ADDENDUM NO. 1

**EDGEMONT SCHOOL DISTRICT
GREENVILLE & SEELY PLACE SCHOOLS
HVAC UPGRADES AND CAFETERIA RENOVATIONS**

DATE: January 24, 2023

This Addendum consists of three (3) Pages, Sketch SK-A1.0, revised drawings GVES M200, GVES E101, SPES MD100, SPES M100, SPES M101, SPES M102, SPES M103, SPES M104, SPES M200, SPES M203, SPES M300, SPES M400, SPES ER100, SPES ER104, SPES E100, SPES E103, and SPES E104.

1-24-2023	ADDENDUM #1
1-06-2023	BID
DATE	ISSUED TO
SHEET SIZE: 30"x42"	DRAWING NO. SPES M103
SCALE: AS NOTED	FILE NO. 21434.01
DRAWN BY: LFG

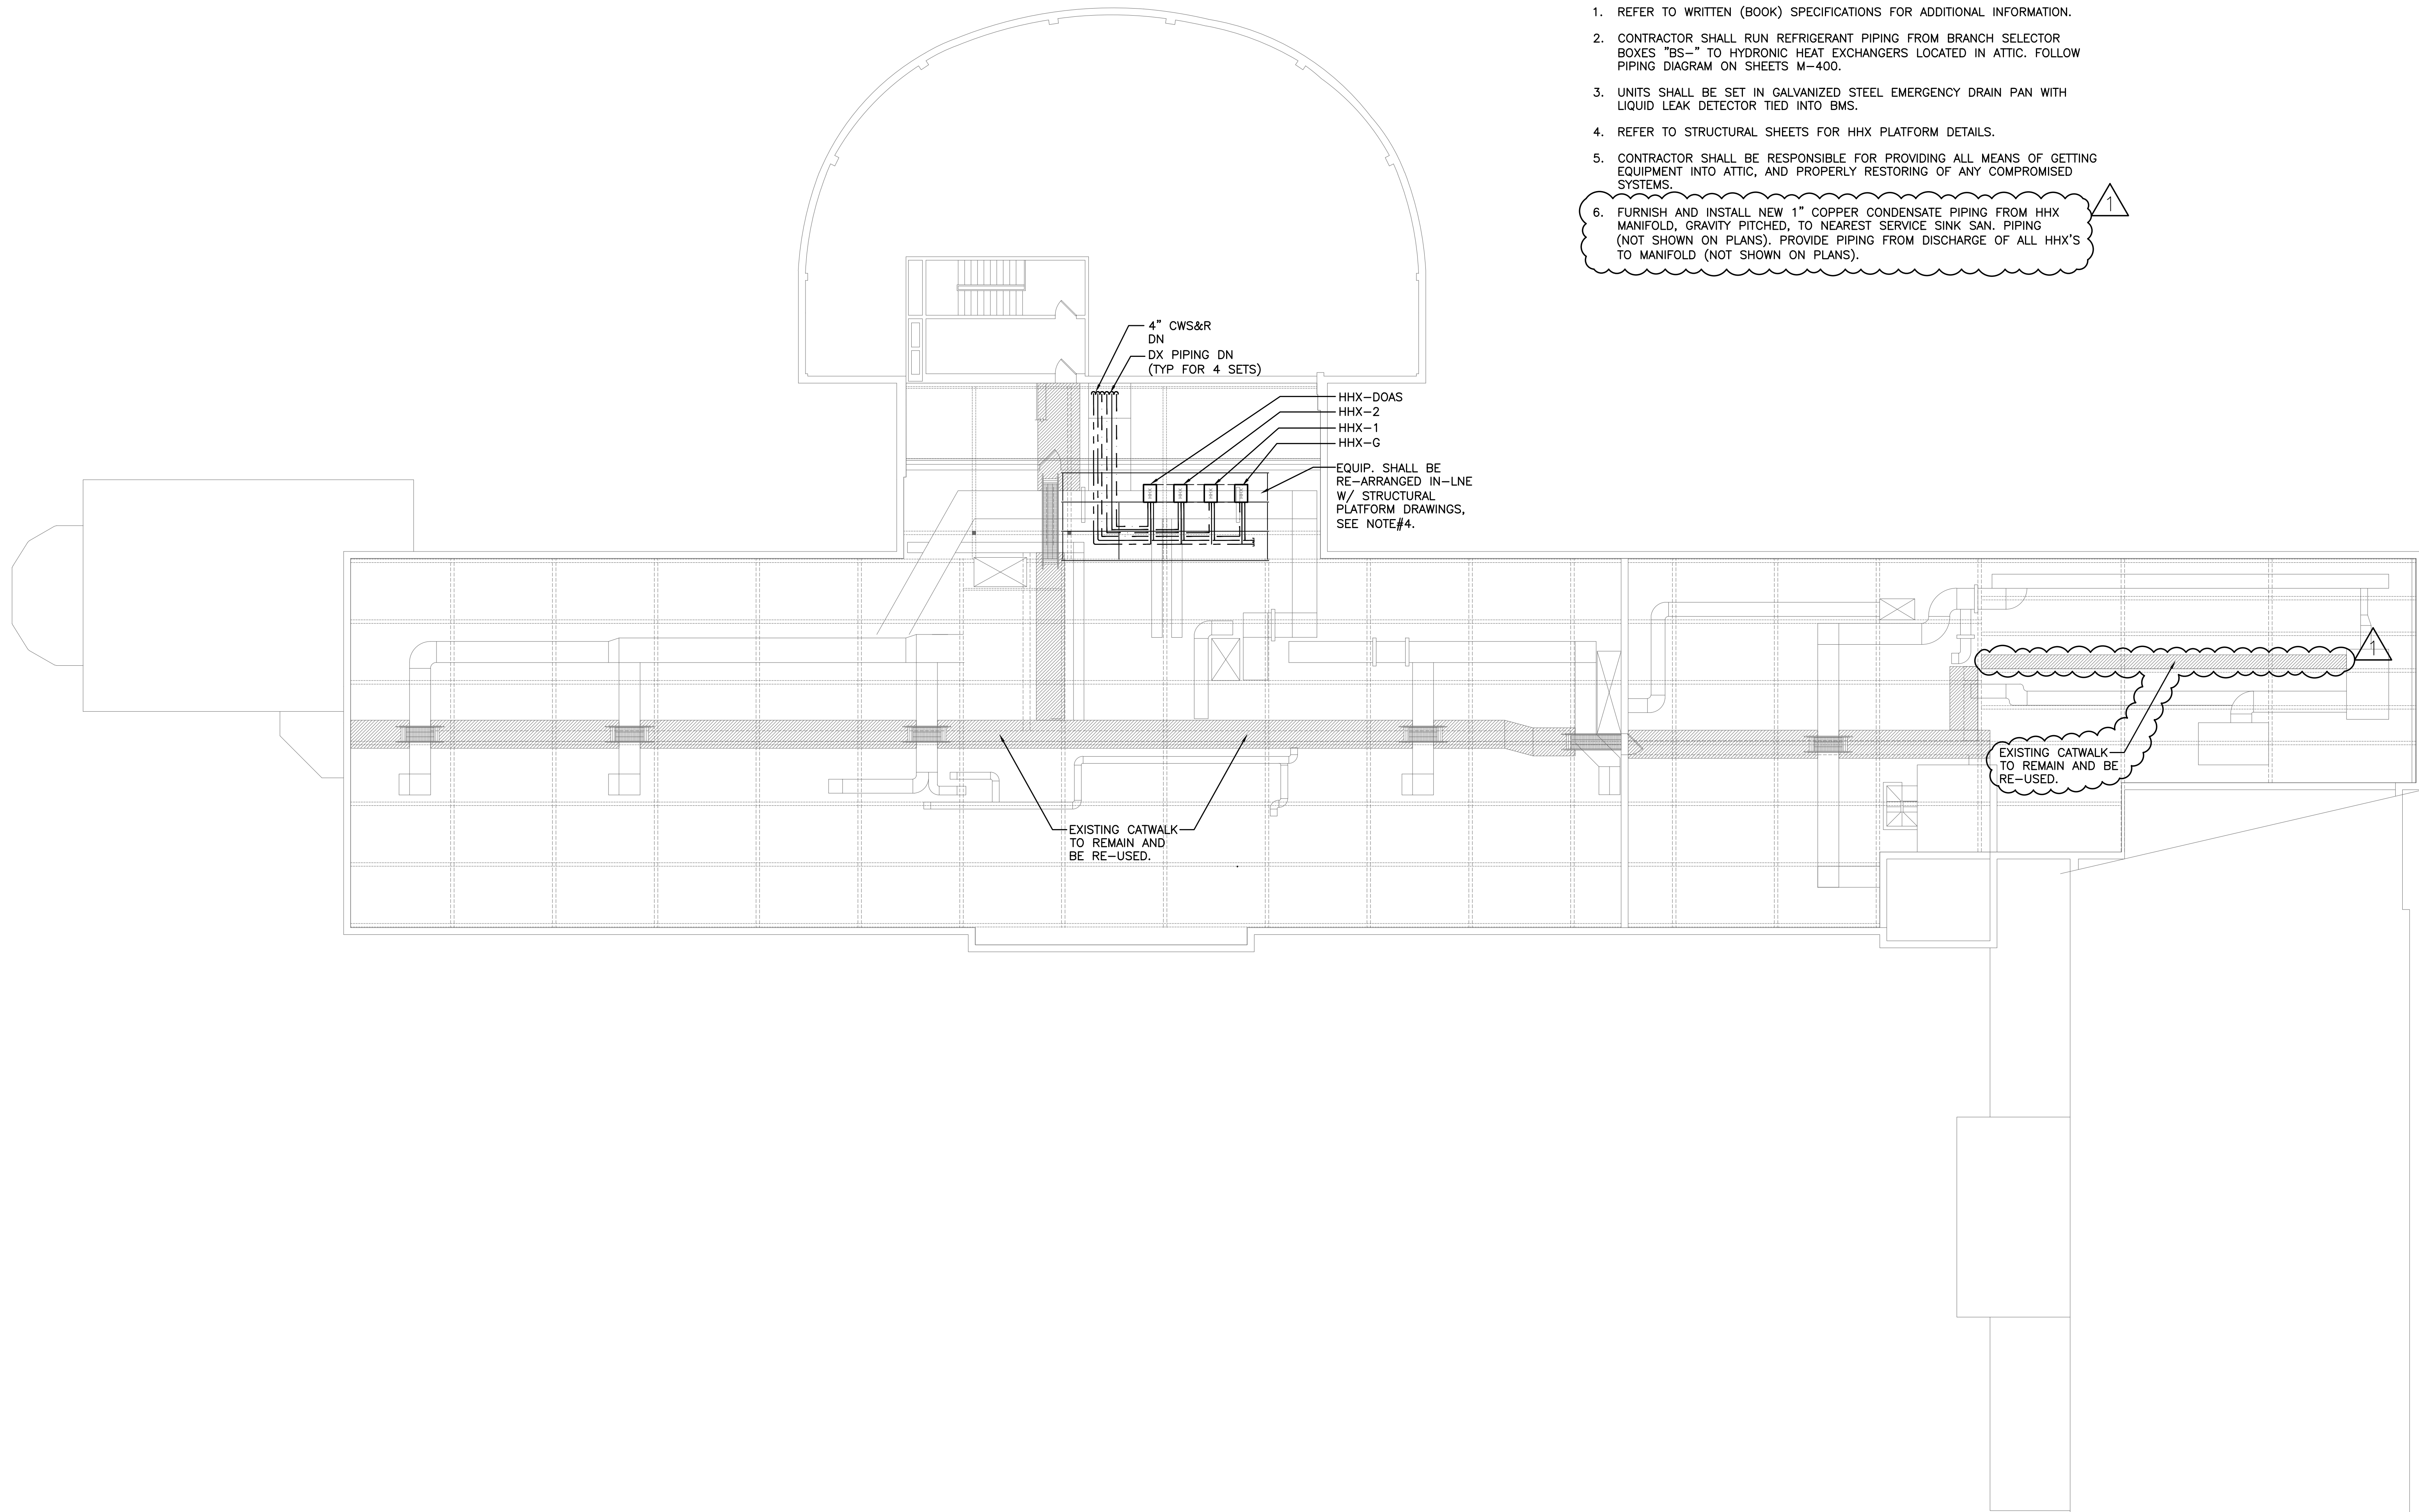
DRAWING SPES M103 – ATTIC MECHANICAL PLAN

Detail 1, **ADD** notes as shown on drawing attached to this addendum.

1. REFER TO WRITTEN (BOOK) SPECIFICATIONS FOR ADDITIONAL INFORMATION.
2. CONTRACTOR SHALL RUN REFRIGERANT PIPING FROM BRANCH SELECTOR BOXES "BS-" TO HYDRONIC HEAT EXCHANGERS LOCATED IN ATTIC. FOLLOW PIPING DIAGRAM ON SHEETS M-400.
3. UNITS SHALL BE SET IN GALVANIZED STEEL EMERGENCY DRAIN PAN WITH LIQUID LEAK DETECTOR TIED INTO BMS.
4. REFER TO STRUCTURAL SHEETS FOR HHX PLATFORM DETAILS.
5. CONTRACTOR SHALL BE RESPONSIBLE FOR PROVIDING ALL MEANS OF GETTING EQUIPMENT INTO ATTIC, AND PROPERLY RESTORING OF ANY COMPROMISED SYSTEMS.
6. FURNISH AND INSTALL NEW 1" COPPER CONDENSATE PIPING FROM HHX MANIFOLD, GRAVITY PITCHED, TO NEAREST SERVICE SINK SAN. PIPING (NOT SHOWN ON PLANS). PROVIDE PIPING FROM DISCHARGE OF ALL HHX'S TO MANIFOLD (NOT SHOWN ON PLANS).

1-08-2023	ADDENDUM #1
1-06-2023	BID
DATE	ISSUED TO
SHEET SIZE: 30"x42"	DRAWING NO. SPES M104
SCALE: AS NOTED	FILE NO. 21434.01
DRAWN BY: LFG

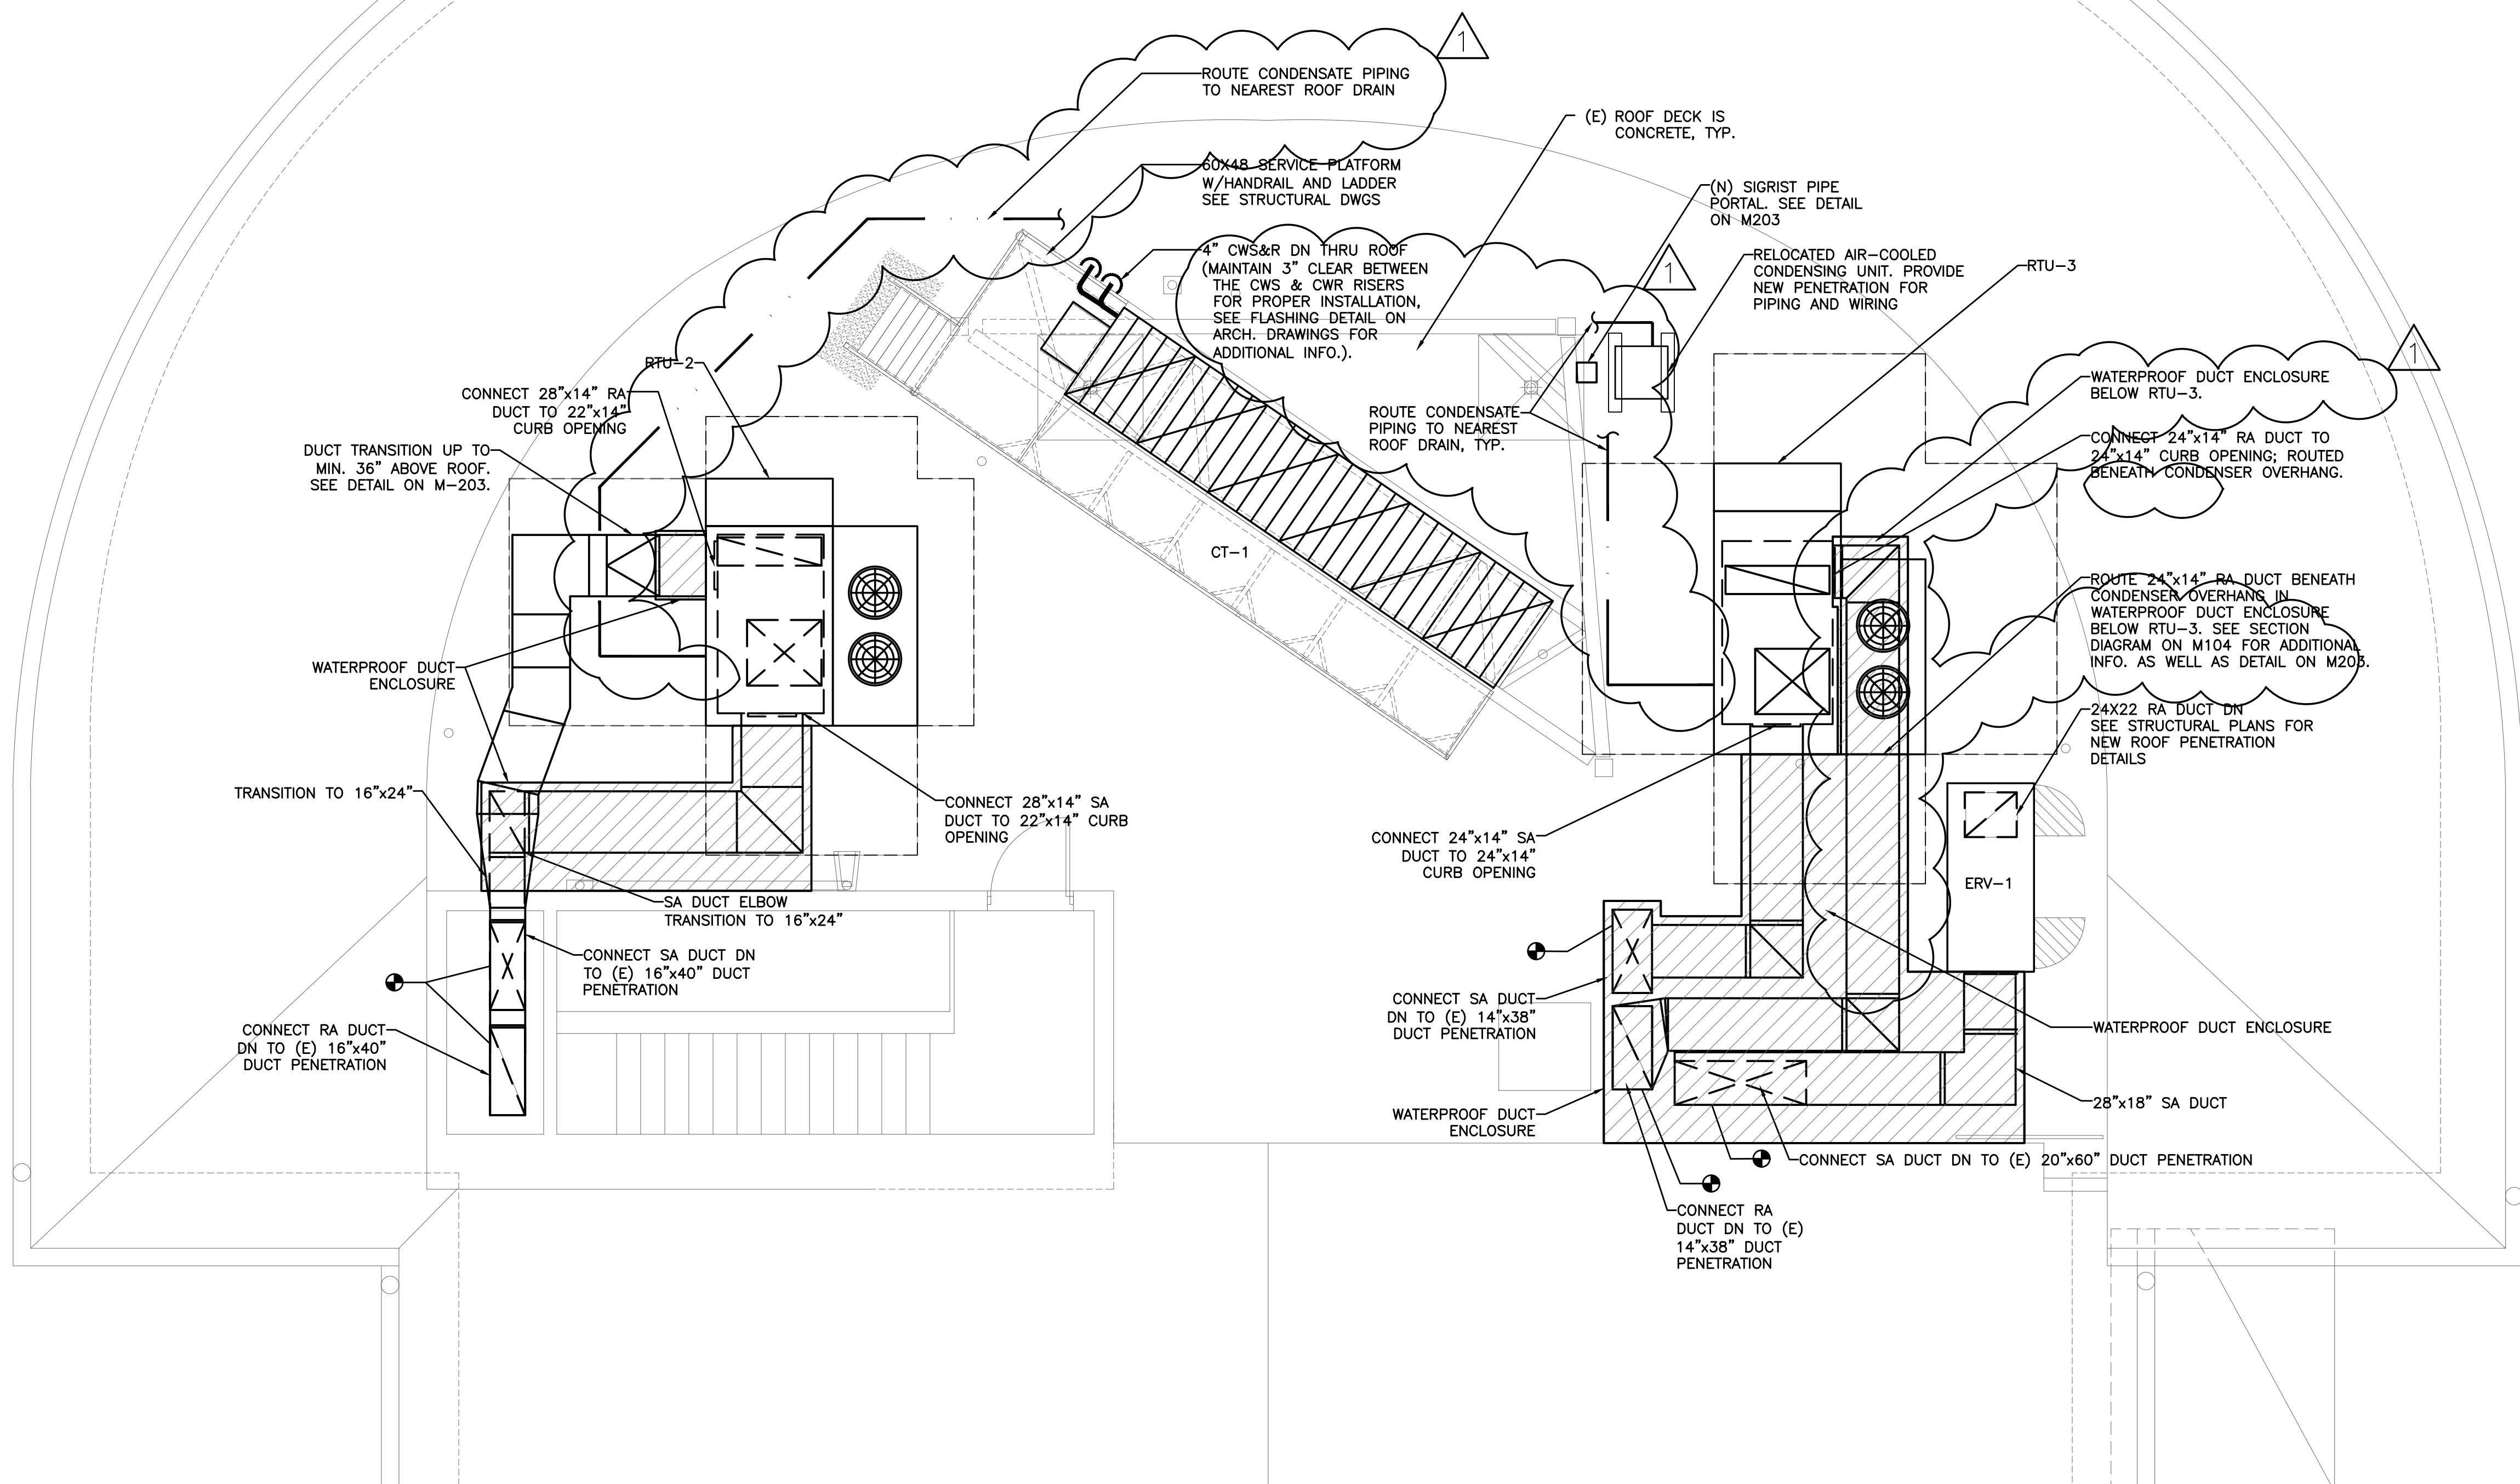
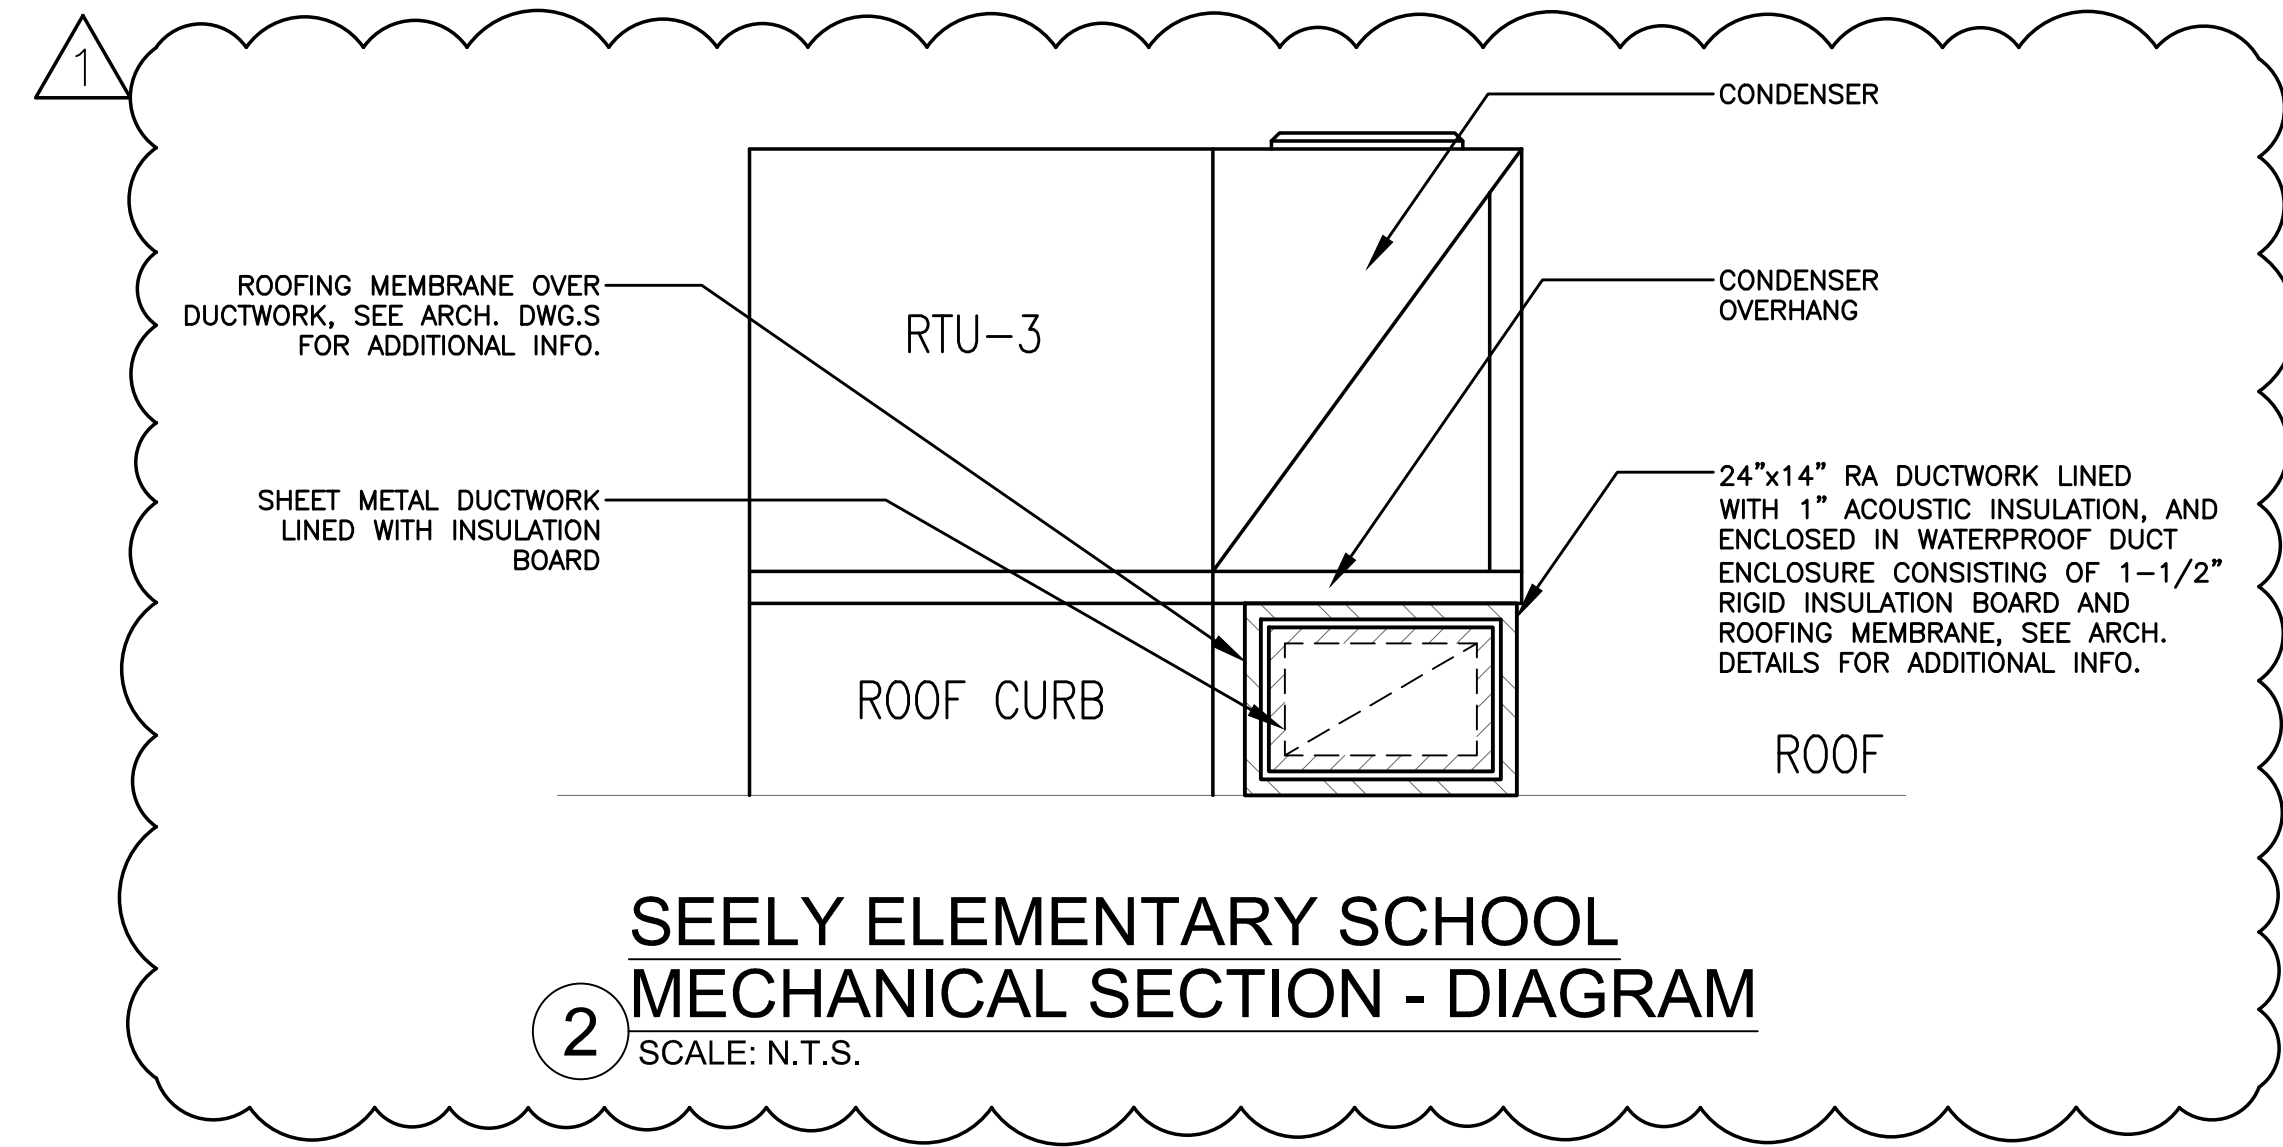
DRAWING SPES M104 – ROOF MECHANICAL PLAN

Detail 1 & 2, **ADD** notes as shown on drawing attached to this addendum.

1. REFER TO WRITTEN (BOOK) SPECIFICATIONS FOR ADDITIONAL INFORMATION.
2. MAINTAIN MANUFACTURER'S RECOMMENDED SERVICE CLEARANCES TO ALL EQUIPMENT ON ROOF. DO NOT OBSTRUCT CLEARANCE WITH DUCTWORK OR OTHER OBJECTS.
3. ROOF PENETRATIONS FOR CW PIPING, GAS PIPING, ELECTRICAL POWER AND CONTROL WIRING SHALL BE MADE USING "SIGRIST PIPE CHASE HOUSINGS" AS MANUFACTURED BY ALTA PRODUCTS. SEE DETAIL ON DRAWING M203. PROVIDE SUBMITTAL FOR ENGINEERING REVIEW WITH HOUSING CONFIGURED FOR EACH INDIVIDUAL ROOF PENETRATION.
4. EXISTING ROOF DECK SHALL BE CONSIDERED CONCRETE UNLESS OTHERWISE NOTED.
